T.I. no.: 2018 - 01 Updated: -	Topic: SCA P BF Software 1.71
--	--------------------------------------

Date: 29.01.2018	Priority	Need for action
Affected machines: SCA P BF	High	As soon as possible
From serial number: 1802../	X Medium	X On next visit to the machine
As of date: -	Low	FYI only

NEW FUNCTIONS AND IMPROVEMENTS

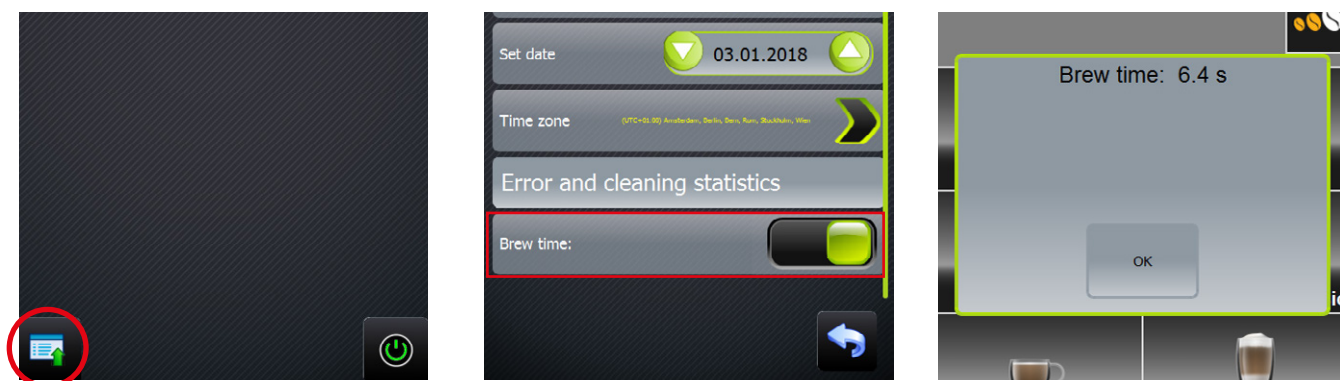
- Thai characters can be displayed on the TouchIT.
- If the machine needs longer than 3 seconds to prepare a cold or hot beverage, a message is displayed.
- Most current version of M2M integrated.
- Recipe ID for MDB payment systems integrated.
- Telemetry integrated via MDB Comms gateway.
- Parallel dispensing of milk via the beverage outlet and coffee via the swan neck.
- Error messages such as "Grounds container empty", "Grinder empty", etc. are also displayed for test beverages.
- Switch-on rinsing with activated milk system only performed when milk is detected.
- The brewing time display is activated in the Quick menu. The brewing time is displayed after beverage dispensing.
